November 15, 2016

Re: 2016 South Boston Municipal Harbor Plan Renewal and Amendment

South Boston Waterfront District Municipal Harbor Plan Amendment and Renewal Substitute Provisions

Figure 2. Water Dependent Use Zone

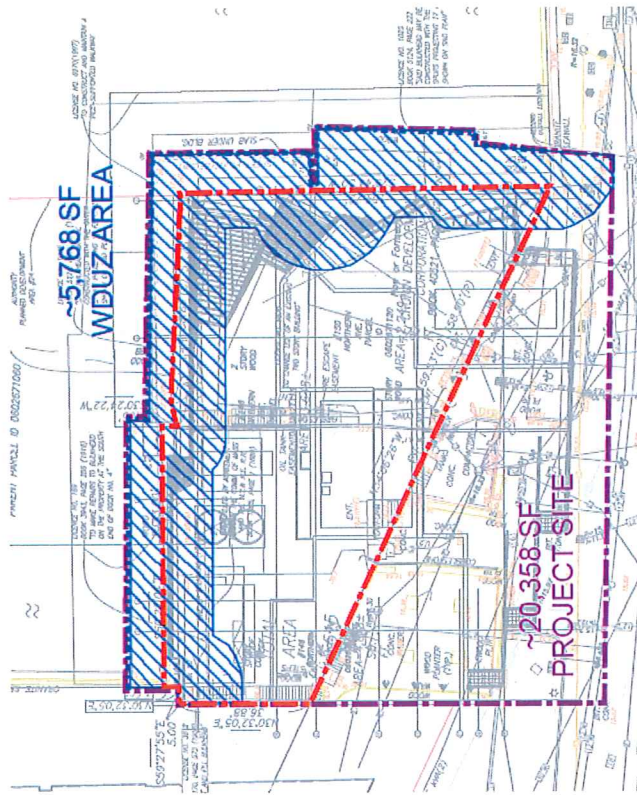
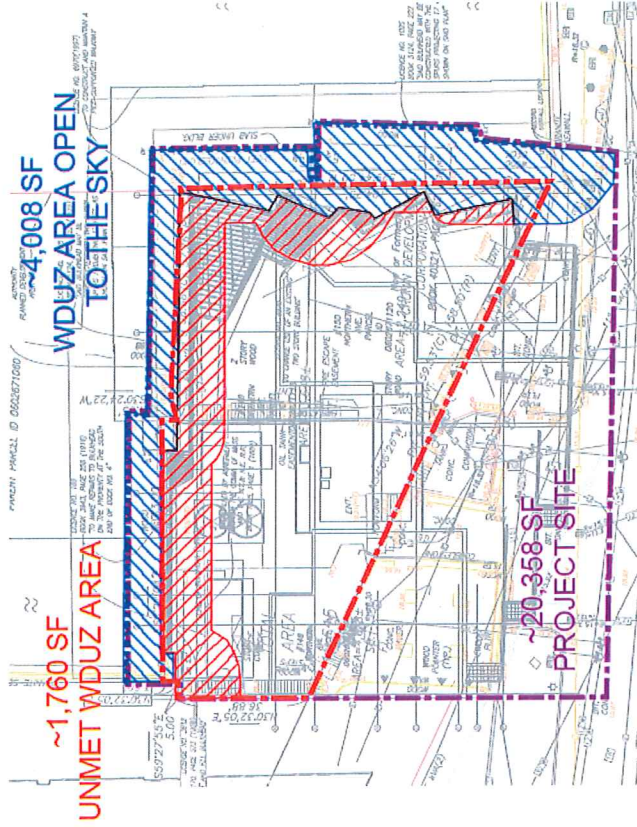
In following with the state's determination on the project shoreline, the area of the associated WDUZ would be 5,768+/- square feet. Under this same regulatory approach, the proposed project would have a WDUZ of 4,008+/- square feet, leaving a WDUZ deficit of 1,760+/- square feet (Figure 2). This deficit will be offset, at a one-square-foot-to-one-square-foot ratio, through a reconfiguration of the WDUZ that includes the construction of a pile-supported wharf area, known as Massport Wharf, along the existing Seaport Boulevard shoreline to the east of the project site, toward the World Trade Center (Figure 4). The preferred area for Massport Wharf shall be an area seaward of and parallel to Seaport Boulevard, and this wharf shall connect Seaport Wharf with the World Trade Center with an enhanced Harborwalk area and water transportation waiting area. An alternative area that would extend Seaport Wharf southeasterly from the project site may also be constructed as a WDUZ offset, but only if reasonable efforts are unsuccessful to complete the offset at the preferred area in the same timeframe as the completion of the 150 Seaport Boulevard project.

Figure 3. Modified Regulatory Approach to 150 Seaport Boulevard

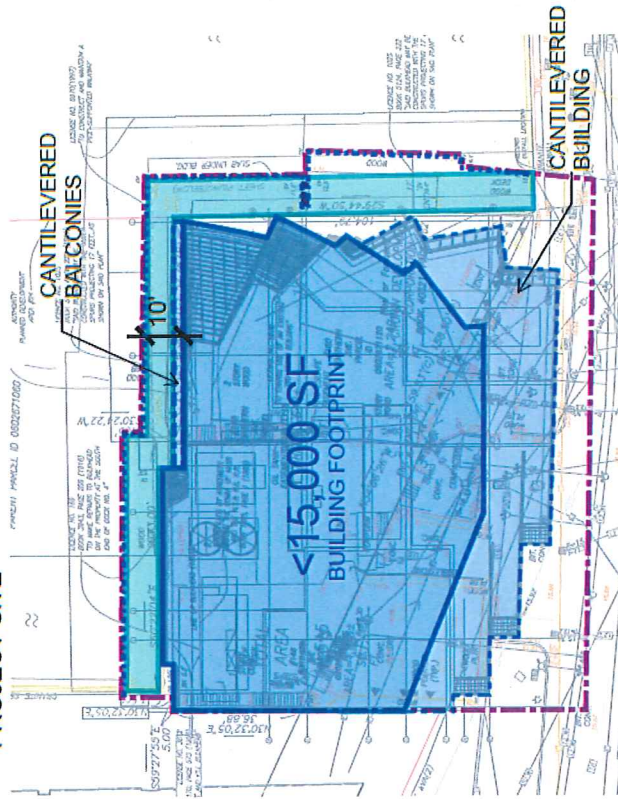
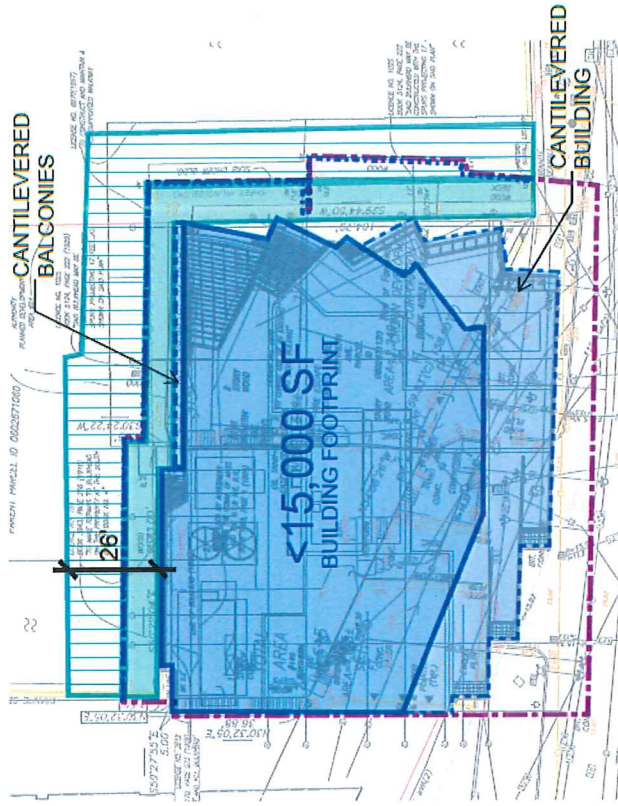
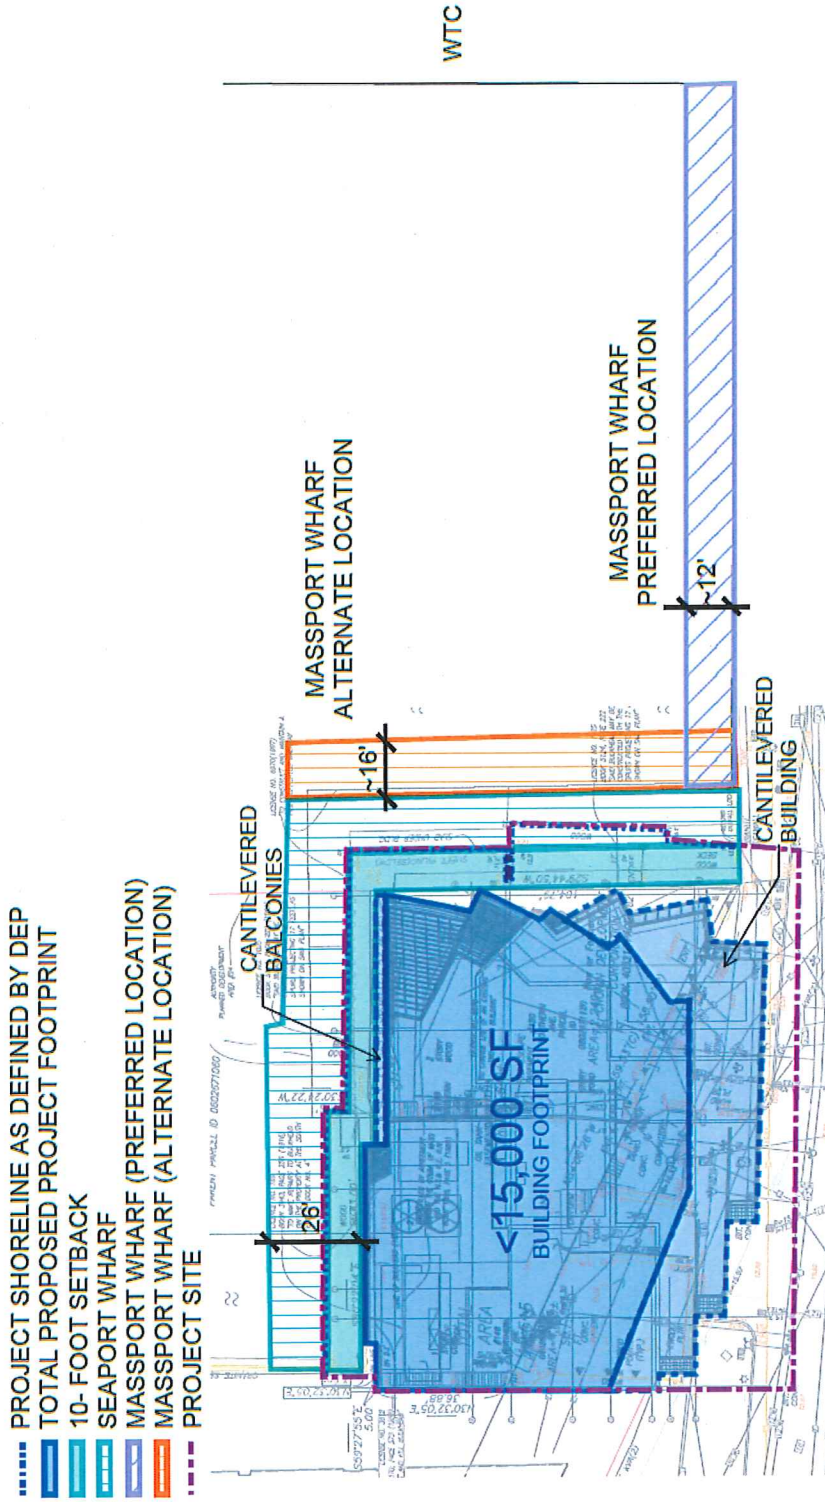
Lot coverage shall be reduced from a maximum of 15,600 square feet as submitted to a maximum of 15,000 square feet (Figure 3). While the overall lot coverage for the project has decreased under this approach, the percentage of lot coverage has increased from a maximum of 70% as submitted to a maximum of 75%. Under this approach the amount of open space area to be offset is 4,821 square feet.

The proposed building will be reconfigured to ensure a minimum 10-foot setback at the ground level from the project shoreline to meet the minimum standards in the Waterways regulations. A moderate amount of cantilevered balcony areas shall be allowed over this 10-foot setback area but no less than 45-feet above the ground level. Any area underneath the cantilevered balcony areas shall not be counted as part of the WDUZ or as open space.

The proposed Seaport Wharf open space area seaward of the project shoreline has received considerable public support (Figure 3). However, as explained above, the complex ownership, regulatory, and licensing issues and the relatively small size of the parcel complicate a straight-forward approach to ensuring that the public access and water dependent use goals of Chapter 91, the Waterways regulations, and the MHP regulations are met. It is precisely these types of extraordinary circumstances for which the MHP regulations are uniquely qualified. This amplification will ensure that Seaport Wharf will be an integral component of this project, fulfilling a long-standing public realm priority for this site and the intent of Waterways License #6970 and its related licensing efforts.

Figure 4. Modified Regulatory Approach to 150 Seaport Boulevard

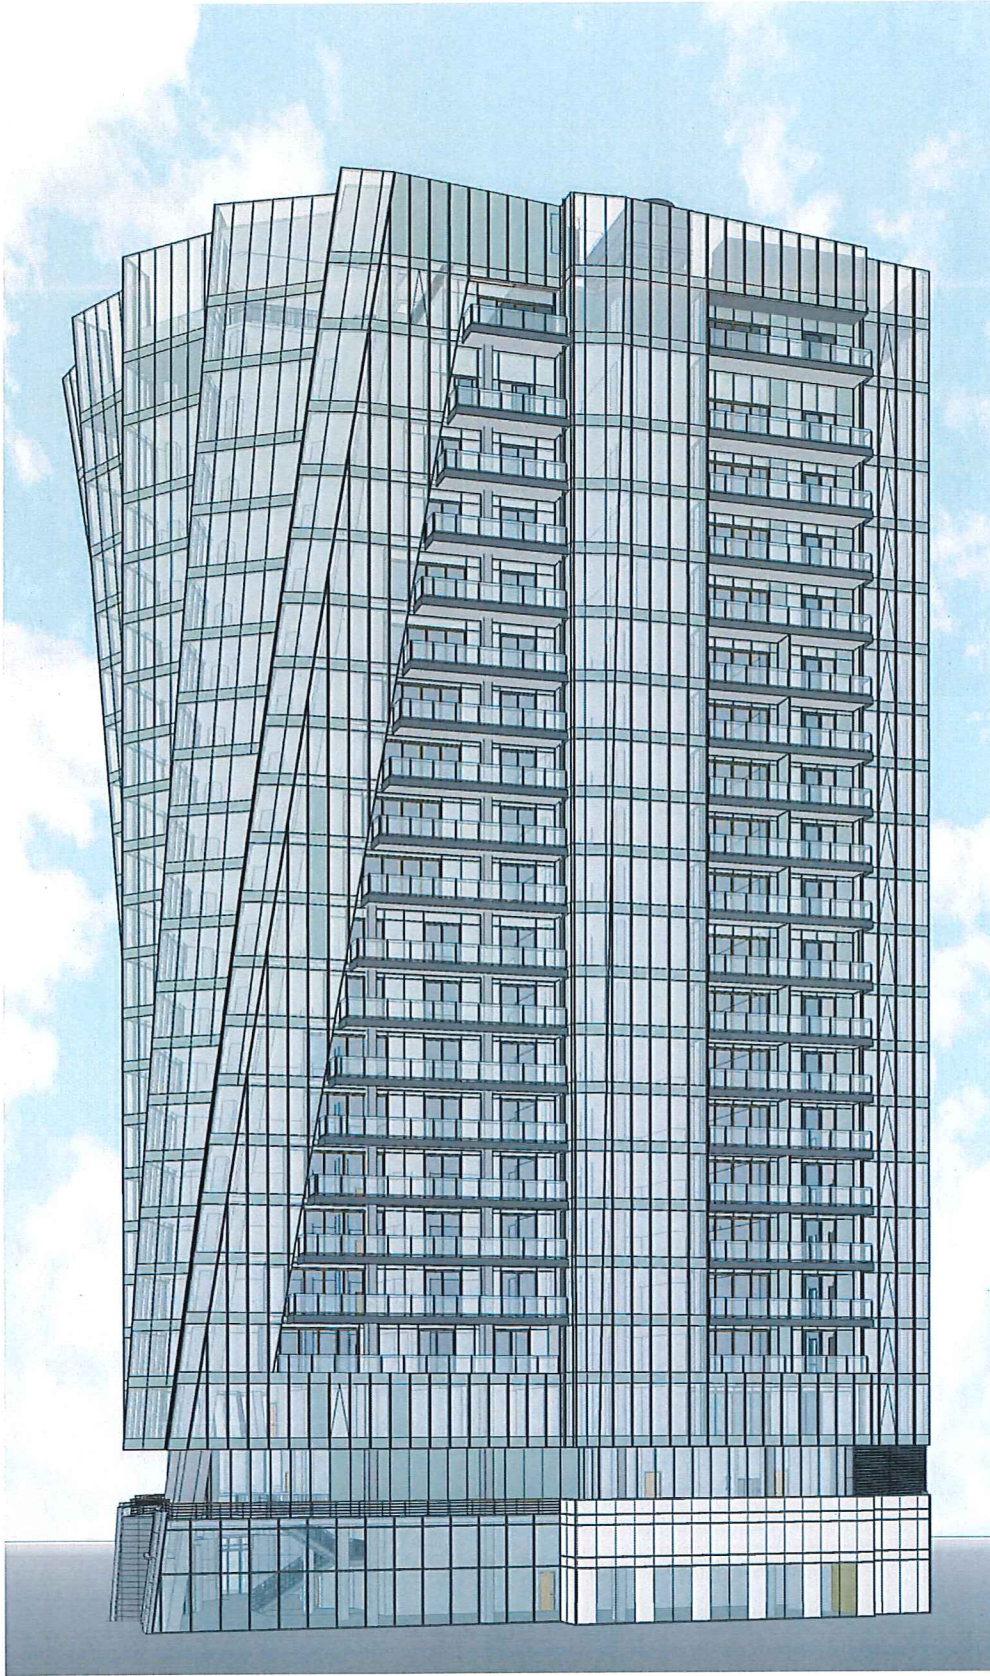
Recognizing existing site constraints, such as no public access to the water, no water dependent uses, and no waterfront activation, and given the relatively small size of the project site, the City is requesting that the Secretary amplify the discretionary requirements of 310 CMR 9.53(2) by requiring an open space area known as Seaport Wharf of not more than 5,000 square feet seaward of the project shoreline. This amplification will result in a significant public exterior area that is open year-round to the public, completing long awaited City public realm plans and fulfilling Chapter 91 public access goals.
